**Car Stereo
Service Bulletin**

Model: CDX-6020/R77

No. 229

Subject: Transistor Q702 Is Missing From The Service Manual

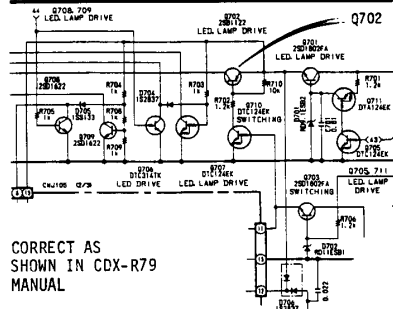
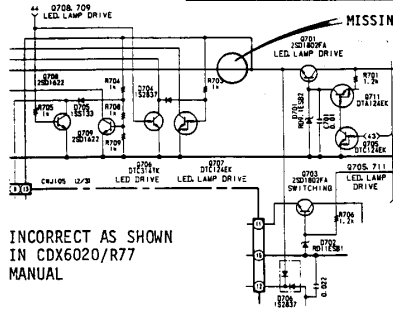
Transistor Q702, the LED, LAMP DRIVE is not shown in the Service Manual schematic or board layout.

Solution: Please refer to CDX-R79 Service Manual for the location and part number of Q702.

REFERENCE NUMBER	DESCRIPTION	PART NUMBER
Q702	TRANSISTOR 2SB1122-T	8-729-804-42
